**PARTS LIST FOR WAR20LWLCLH
REEL ASM. No. 1366194 (WAR20LWLCLH)**

MRP Ver 022822

Penn Reel Parts list for Model: Warfare Levelwind WAR20LWLCLH Line Counter (LEFT HANDED)

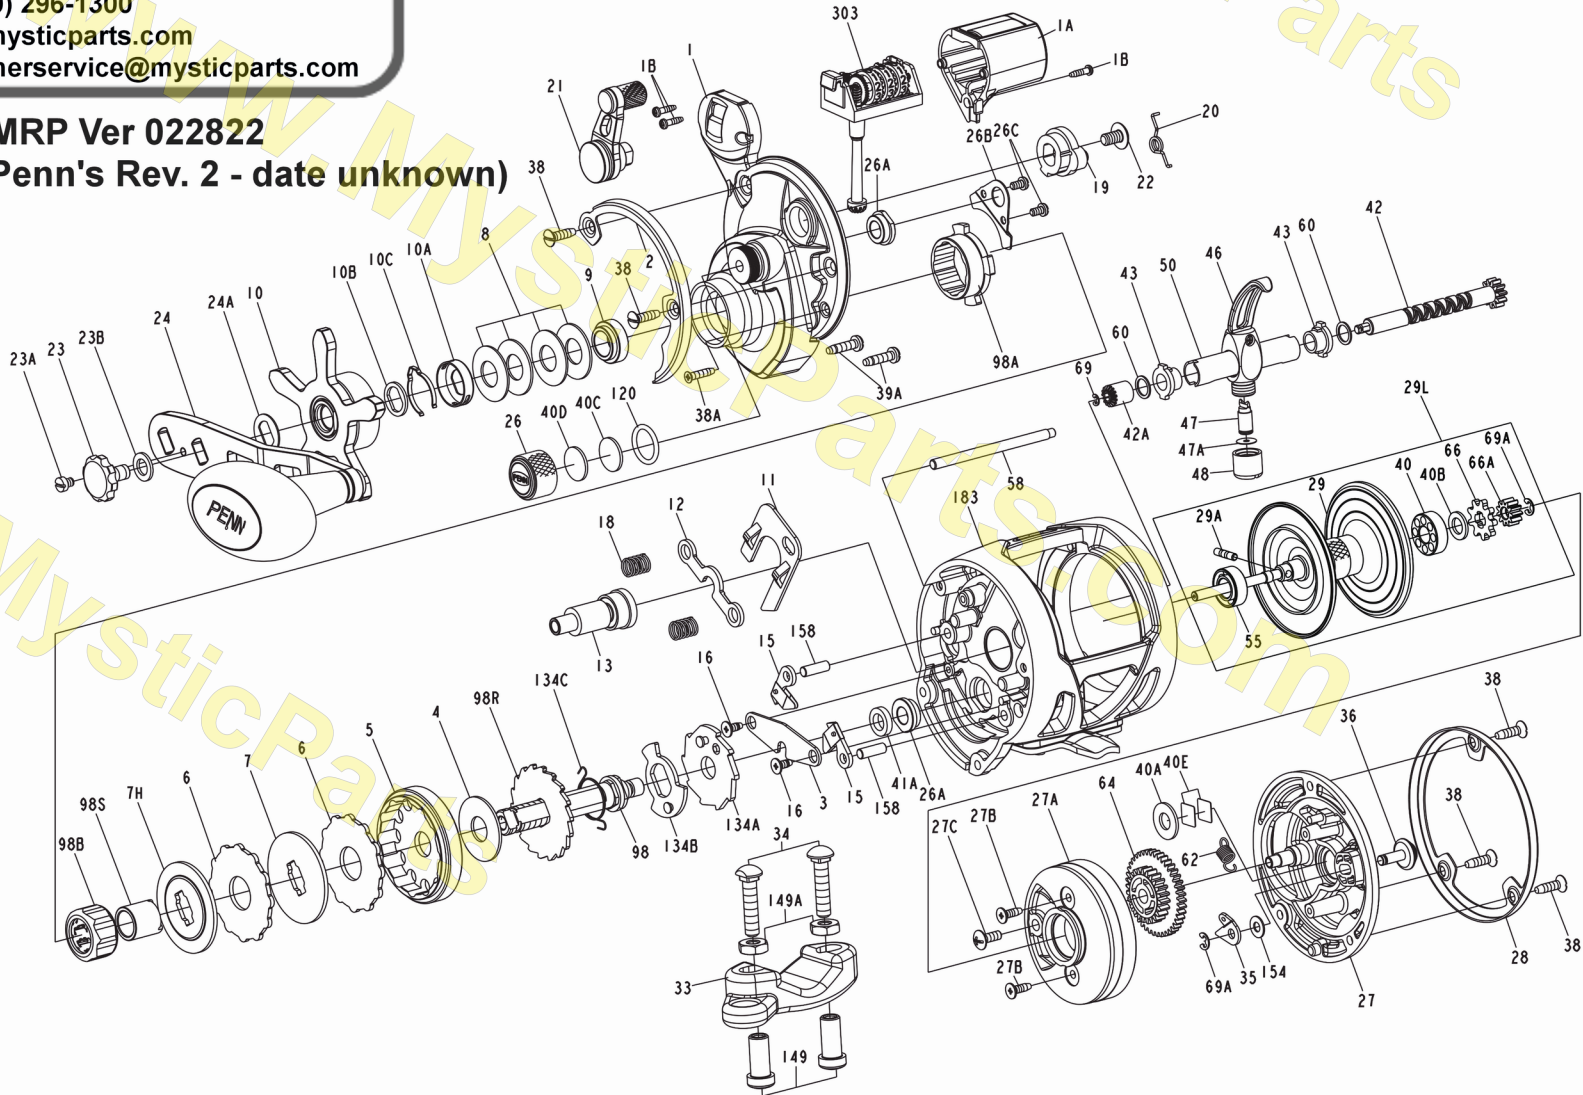
**** WARNING about LEFT HANDED PARTS!! Rev. 0 of the Penn schematic had typos for parts #2, 5, 10, 11, 13,19, and 20.**

Some Standard part numbers were listed in error on Penn's rev 0 and rev 2 for these reels!

This schematic has been revised to reflect that these parts have LEFT HANDED versions and different part numbers are required!

*40B rev.0 of schematic said felt, but what was in the reels were plastic

* 62 - HAD TWO KINDS 7 COIL AND 5 COIL, SEEMED RANDOM

69	1383065	69-WAR15LW	RETAINER RING (error WRONG on rev 0) do NOT use on LC reels
69	1446770	69-WAR15LWLC*	RETAINER RING (corrected part number specific to the LC reels)
*69 rev. 0 of schematic said 69-WAR15LW, but was actually a different ring, assigned it 69-WAR15LWLC (Penn confirmed it in rev 1)

55	1451533	55-WAR15LW	BEARING (ATTACHED TO SPOOL SHAFT)
NOTE	1191256	20-1000AF	BEARING (ATTACHED TO SPOOL SHAFT) * old key#20A (CAN BE USED IF THE 55 PART IS NOT AVAILABLE)
We originally used 20-1000AF as the spool bearing, which wasn't on the Penn Rev0 schematic, but we now have the correct # 55-WAR15LW			
29A	1451532	29A-WAR15LW	PIN TO HOLD IN SPOOL BEARING

134B	1383096	134B-WAR15LWLH	CLUTCH RECOVER SUPPORT PLATE	Originally noted as an (LEFT HANDED) part
*	1383073	134B-WAR15LW	CLUTCH RECOVER SUPPORT PLATE	but it is the SAME AS the standard part
